Docket Number:	24-OPT-03
Project Title:	Soda Mountain Solar
TN #:	265739
Document Title:	Response to CEC's Request for Information dated July 31 2025
Description:	Response to DR REV 2 DR BIO-1 Response to DR REV 2 DR BIO-2 Supplement to Appendix AA Determination of Infeasibility for DR BIO-20 LADWP Information
Filer:	Hannah Arkin
Organization:	Resolution Environmental
Submitter Role:	Applicant Representative
Submission Date:	8/21/2025 2:16:01 PM
Docketed Date:	8/21/2025

**Subject: Revised Response to REV2 DR BIO-2 Soda Mountain Solar Access Road Assessment
Project Site, in the San Bernardino County, California**

REV 2 DR BIO-2

Figure 1E Proposed Access Road with 50-ft Review Buffer

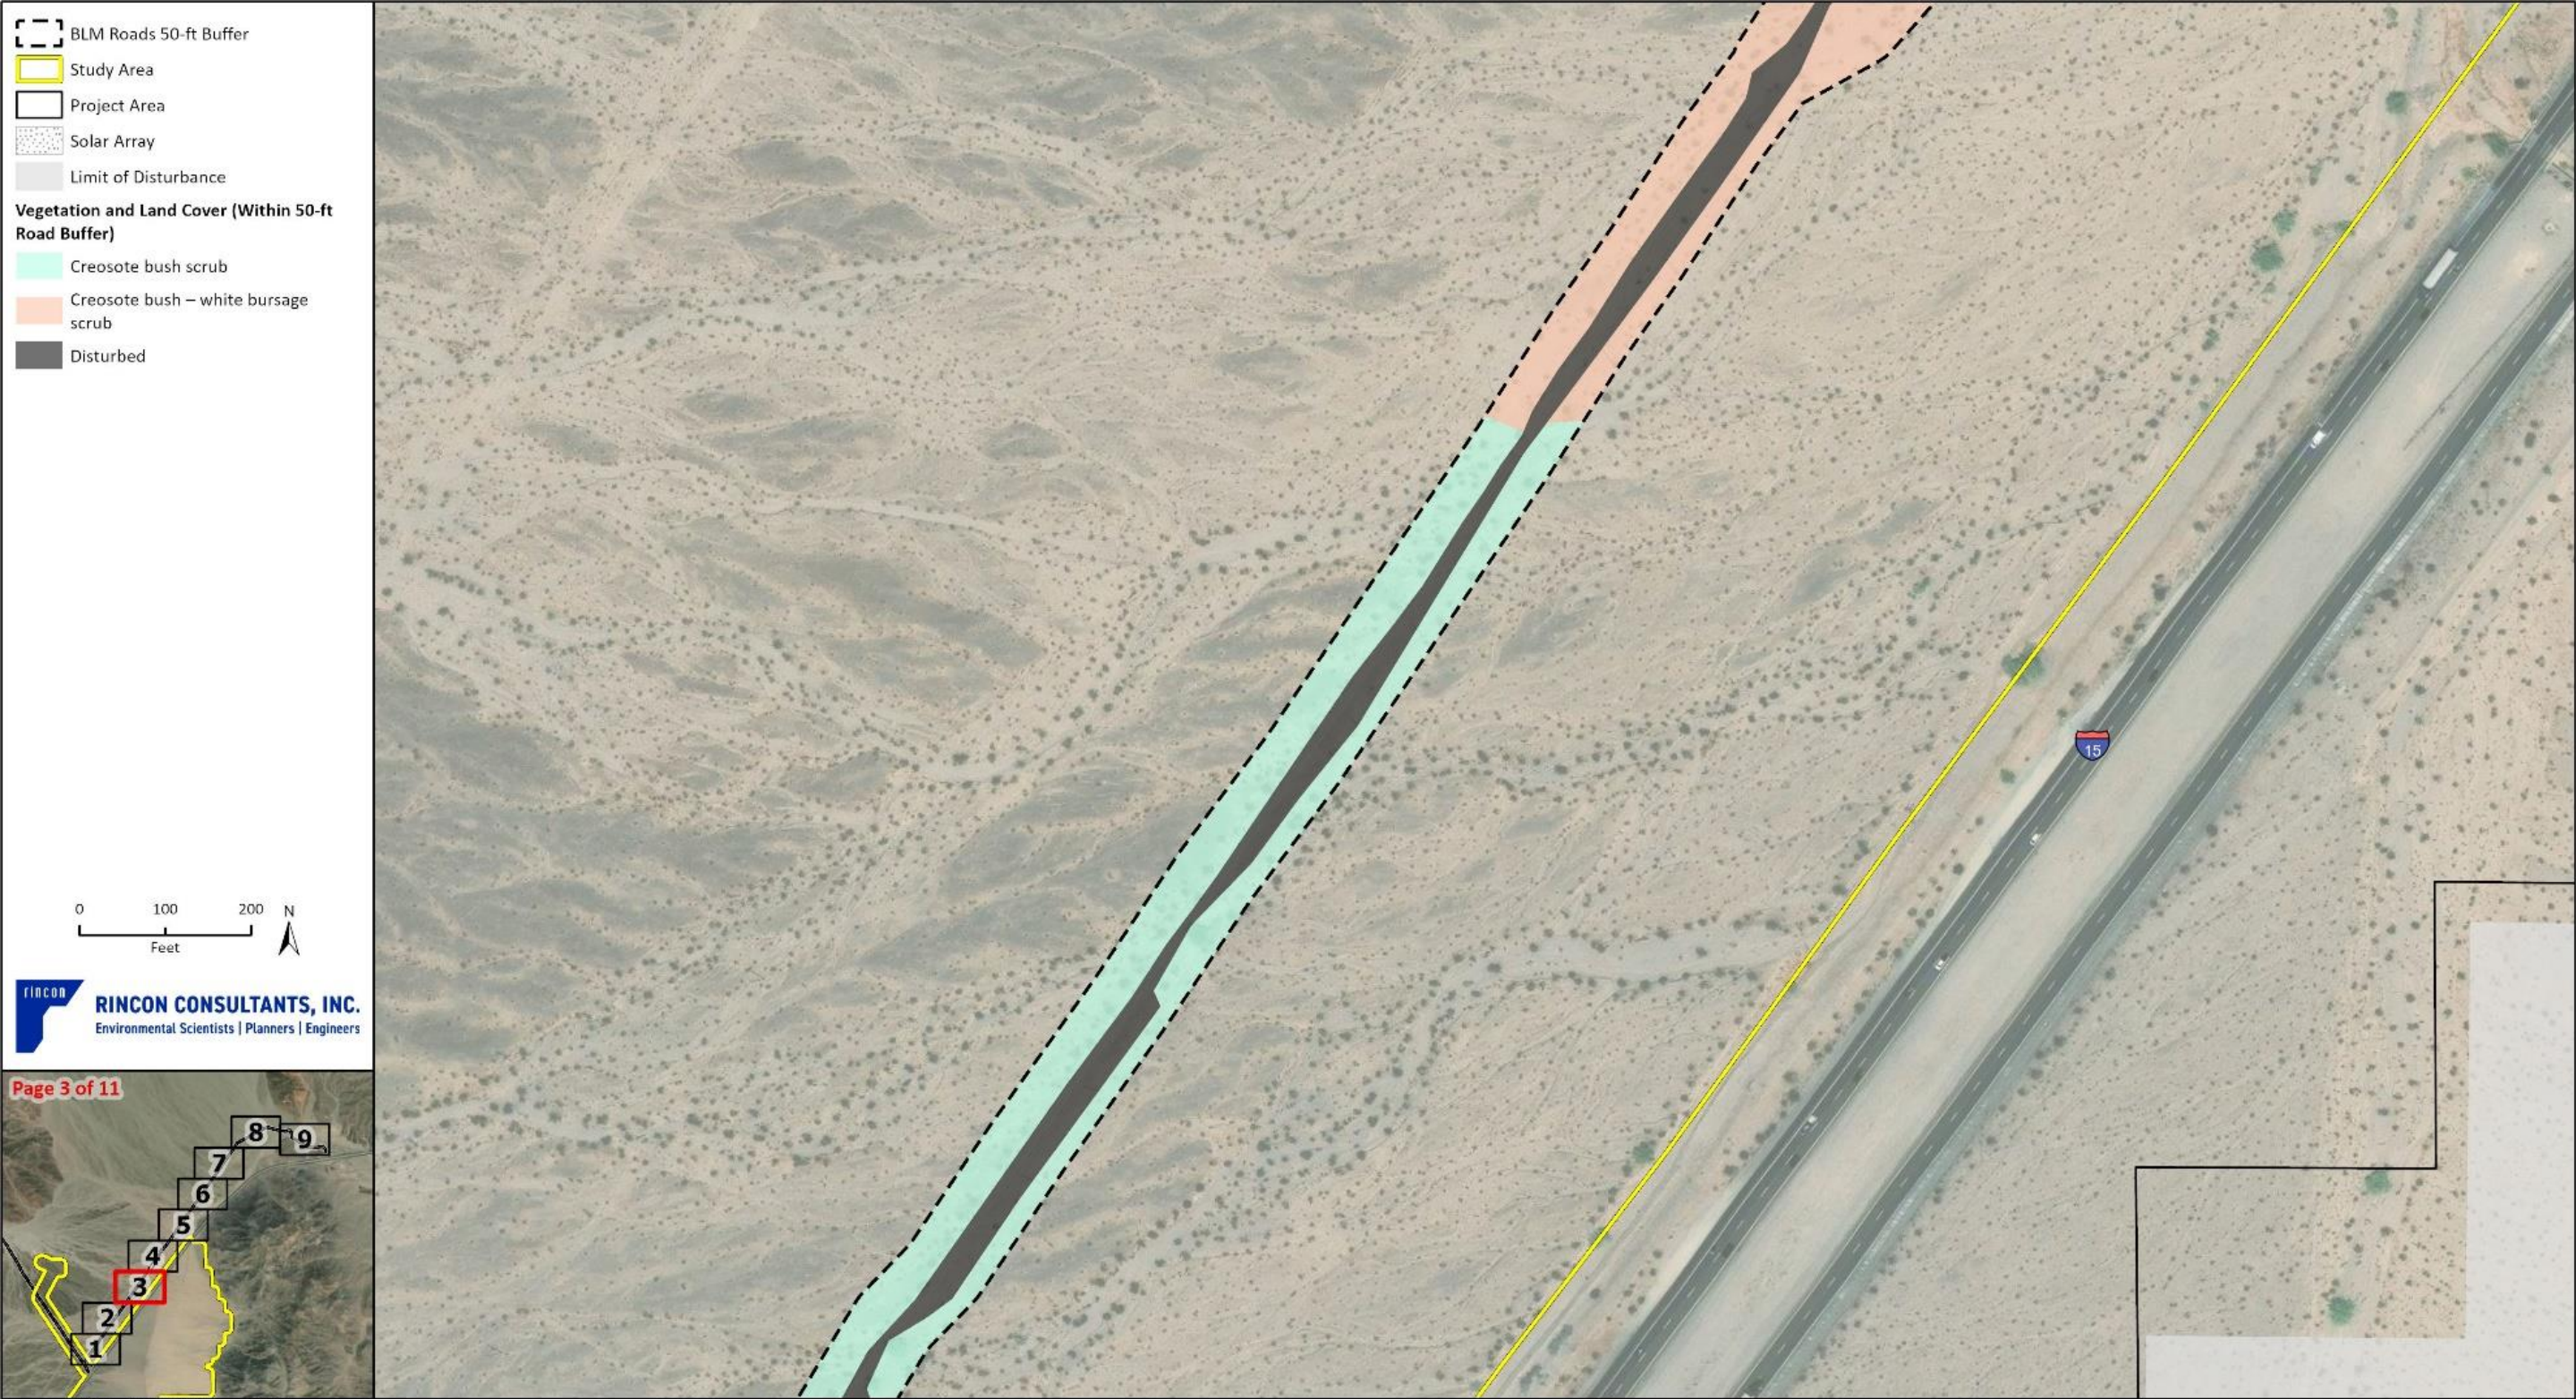
Please confirm if CL8845 is proposed for use as part of the project to access the gen-tie alignment. Additionally, please confirm that BLM roads CL8854, CL8835, CL381A, and CL8837 are not being proposed for use and that these roads are included on the figures for reference purposes only. As previously requested, please also provide biological and jurisdictional waters information that occur within a 50-ft buffer of any proposed access roads and describe any improvements that may need to occur, such as grading or repairs of drainages following large rain events.

Cheesebush – sweetbush scrub is often found in intermittently flooded channels, arroyos and washes, valleys, flats, rarely flooded low-gradient deposits. Soils are alluvial, sandy and gravelly, and disturbed desert pavement. Cheesebush, sweetbush bebbia (*Bebbia juncea*), woolly brickellbush and/or spiny senna (*Senna armata*) is dominant or co-dominant in the shrub canopy with silver cholla, brittlebush, California Mormon tea, Mojave rabbitbush (*Ericameria paniculata*), California buckwheat (*Eriogonum fasciculatum*), sticky snakeweed (*Gutierrezia microcephala*), white ratany (*Krameria grayi*), creosote bush, beavertail cactus (*Opuntia basilaris*), Thurber's sandpaper plant (*Petalonyx thurberi*), Schott's pygmycedar (*Peucephyllum schottii*), desert Christmas tree (*Pholisma arenarium*), Mexican bladdersage (*Salazaria mexicana*), desert purple sage (*Salvia dorrii*) and desert globemallow (*Sphaeralcea ambigua*). Emergent trees or tall shrubs may be present at low cover, including desert-willow (*Chilopsis linearis*), desert lavender (*Hyptis emoryi*), desert ironwood (*Oleña tesota*), blue palo verde (*Parkinsonia florida*), smoke tree (*Psorothamnus spinosus*) or catclaw (*Senegalia greggii*). Approximately 2.82 acres of cheesebush – sweetbush scrub were observed during the field verification surveys. This includes an additional survey buffer that was added to adjust for a shift in the access road (Figure 1E).
